Addendum No. 1

“Phase 1b – Contract C2 – Water Treatment Plant
Illinois Alluvial Regional Water Company
Jersey County, Illinois

October 4, 2026

SHEET NO.
C2

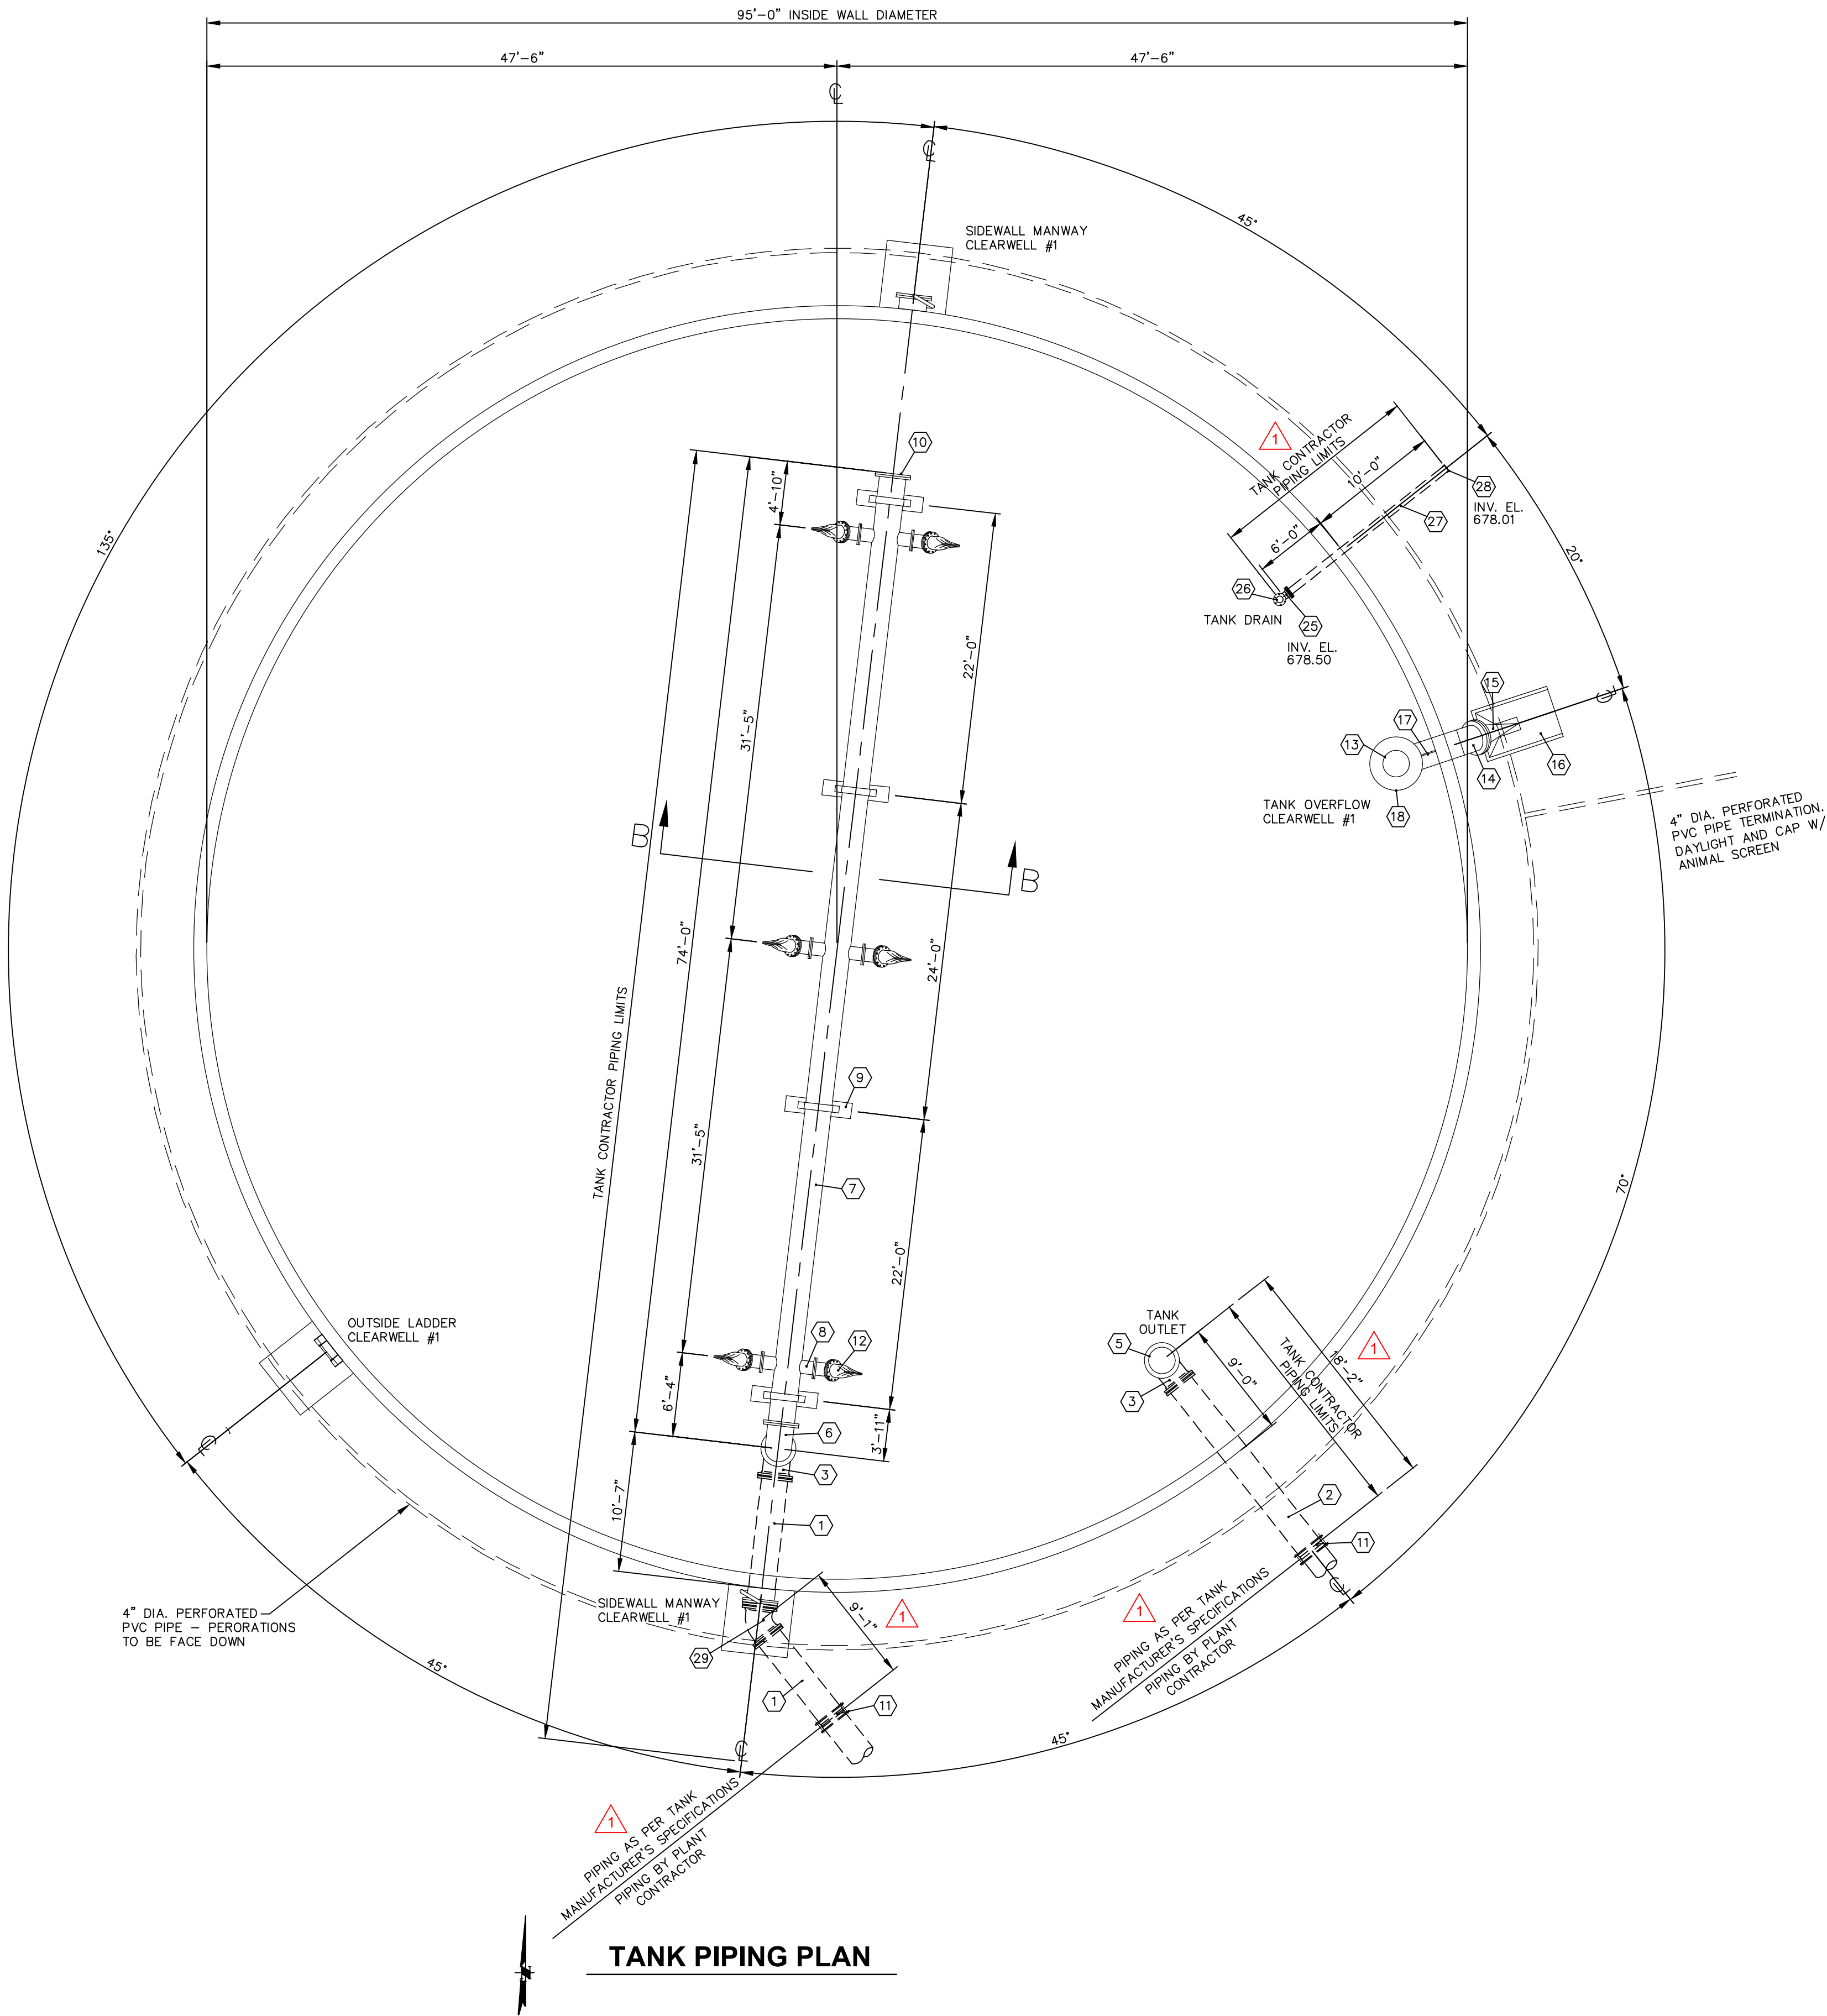
- A. Drawing Sheet C2 has been revised. The attached sheet C2 Revision 4 replaces any previous version of Sheet C2.

- 5. Sheet C2: The grading plan shows clusters of gradation marks at the north, east and west sides of the proposed tank that are not easily discernable. Please confirm the high and low finish grade elevations around that proposed tank as this may greatly affect the penetrations (manways, overflow pipe, etc.) through the tank wall. With the proposed tank having a relatively short wall height, grouping these penetrations at the same elevation would be advantageous, if possible. Additionally, please confirm that the low finish grade elevation around the proposed tank may be raised above the proposed tank floor elevation to provide the minimum 30-inch embedment required in the Terracon IARWC Proposed Water Treatment Plant Geotechnical Engineering Report dated June 5, 2025. **Please see Sheet C-2 Rev 4 in Addendum #1 (forthcoming) to address the revised grades, maintain planned pipe penetrations and alignments.**

MODIFIED GRADING AROUND CLEARWELL NO. 1
FOR MIN. FOUNDATION COVERAGE

SHEET NO.
T6

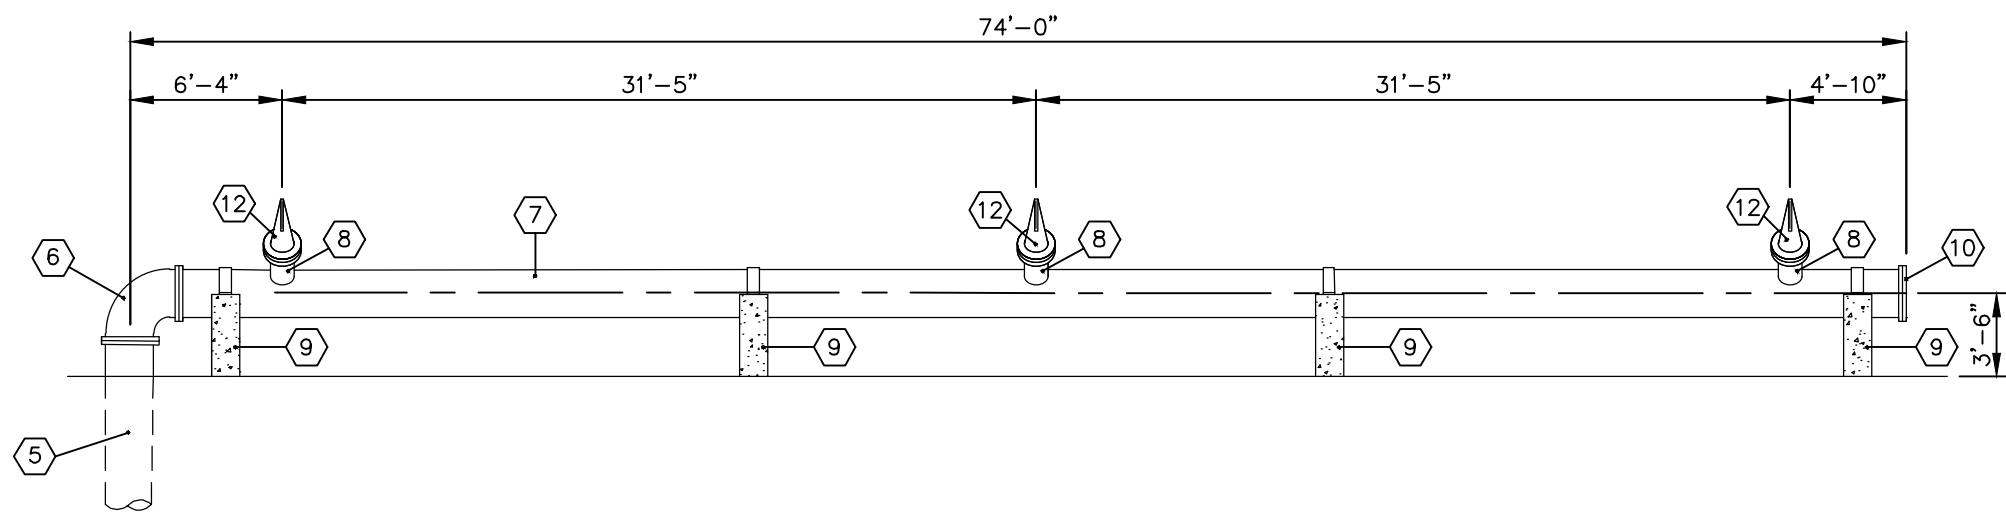
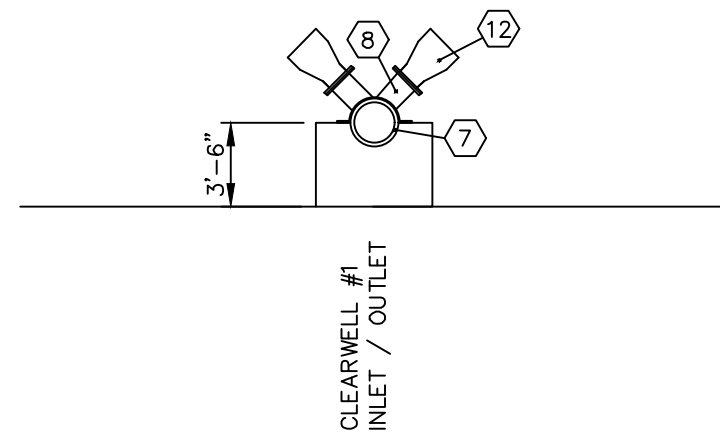
7. Sheet T1, Detail 1 (Tank No. 1 Plan): Please confirm the 3-inch sensing line is not applicable to this project and should be removed. **Correct.**
8. Sheet T1, Detail 1 (Tank No. 1 Plan): The distances shown for the through-floor piping from the inside of the proposed tank wall differ from Sheet T6, Tank Piping Plan. Please clarify the required distances from the inside of the proposed tank wall to the through-floor inlet, outlet and drain pipes. **Use dimensions on Sheet T6.**

10. Sheets C2, T1 and T6 all show different configurations of the piping and appurtenance based on the provided North arrows. Since the height of the proposed tank through-wall piping and appurtenances needs to be confirmed with the final tank backfill elevations, please clarify the plan location of the piping and appurtenances based on a unified North arrow direction. **Use orientations shown on Sheet T6.**

REVISIONS		ADDED INFORMATION ABOUT LIMITS OF TANK SUPPLIER PIPING			
NO.	DATE	DESCRIPTION	DATE	DESCRIPTION	DATE
1	10/05/26	ADDED INFORMATION ABOUT LIMITS OF TANK SUPPLIER PIPING
